Seattle
Design
Commission

APPROVED
MINUTES OF THE MEETING
6 May 2004

Projects Reviewed

South Day Street
Jefferson Park Golf Driving Range
South Park Library

Proposed View Platform

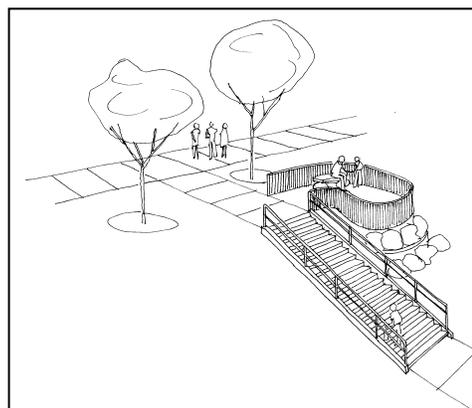
- Has the applicant determined what invasive plants there are in the right-of-way and if removing the plants in the right-of-way – even if they are invasive – would mean a loss of habitat for local wildlife?
 - Applicants said there are morning glory (*calystegia sepium*), ivy (*hedera hibernica*), blackberry (*rubus laciniatus*), and holly bushes (*ilex aquifolium*) in the right-of-way.
- In order to properly evaluate the proposal, we need to know the size of the buildings that will be proposed and how they will affect the views from the viewing platform. Also we need to know what will be planted on the planting strip between the building and the stairs.

- Applicants said that he would probably build a 2 story building with a basement.
- With the ability to build to 35 feet, the potential exists that the viewpoint would be blocked.

- Applicants said that they would be willing to enter into a covenant to restrict the height of the house.
- It is troubling to build into the right-of-way.

- The stairs in question are part of a network of stairs in the area. The stairs are charming, and since they are on a steep slope, they are the “highest and best use” of the right-of-way. Placing a building 5 feet from the stairs would create a radically different experience. The benefits of the platform do not outweigh the benefits of the existing stairs.

- The viewing platform might not bring in more people to the area, therefore there is little benefit to the public.
 - Applicant said the existing stairs were not well used. However, the viewing platform could be used both year-round, and for special events such as SeaFair.

- Concerned that if the viewing platform is deeded to the city without maintenance funds, the platform would not be maintained.
- If the city does need this land in the future, it will be difficult and costly to do so -- it is not easy to condemn land in Washington State.

- The primary benefit of the proposal is not to the city it is to the two property owners.

The Commission's decisions regarding vacations are based on two steps: first, an appropriateness for the urban design of the neighborhood and the good of the city; and second, an evaluation of whether the public benefits stemming from a vacation warrant the Commission recommending the granting of a vacation. The Commissions' consensus is that this project does not meet the first step; therefore, the Commission does not recommend approval.

- The city would be giving up land for future potential use and the proposed remedy should the city need to reacquire the land – eminent domain – is a difficult and expensive proposition;
- The issue of the maintenance of the right-of-way could be solved in some other way than through the proposed vacation;
- The proposal to deed the viewing platform to the city does not meet a public purpose by virtue of its location and does not include a continuing maintenance agreement.

Jefferson Park Grading and Turf Layout Plan

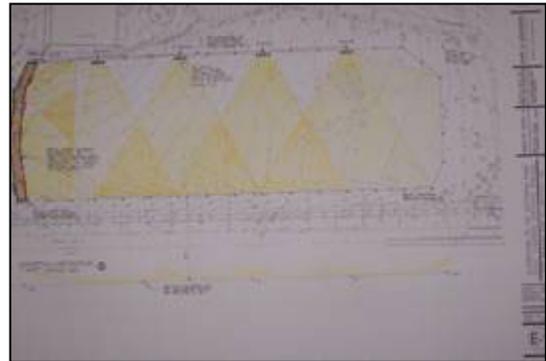
- What opportunities exist for a more natural drainage system? Why would you be looking at artificial turf and not grass?
 - Artificial turf is cheaper to operate.

- Is it a financial decision to use artificial turf?
 - Artificial turf is cheaper to operate but grass is cheaper to install.
- What are the sustainable components?

- No money in budget to landscape buffer or add a trail; perhaps could be done in Phase II.
- Look at a cost/benefit of natural grass vs. artificial turf. The amount of green space in the city is small and ever diminishing; do we want to start permitting artificial turf in parks?

- Consider grading the range when fixing the drainage system.
- Think more adventurously about the poles and nets, like perhaps adding flags, changing the color at a high level, adding stencils to the nets, and including a periscope in one of the poles.

- Appreciates the proponents' care with which they thought about both the park and the community throughout the design process;
- Appreciates the work to date with the community in developing the design and encourages further work with the community to look at ways of either celebrating or concealing the nets and/or poles;
- Given that light pollution is a concern throughout the city, appreciate the attention given to improving the lighting and minimizing light spillover into the park and community;
- Appreciate the exploration of enriching the groundplain and ways to integrate the stormwater and infiltration facilities; and
- Recommends approval of the design development.
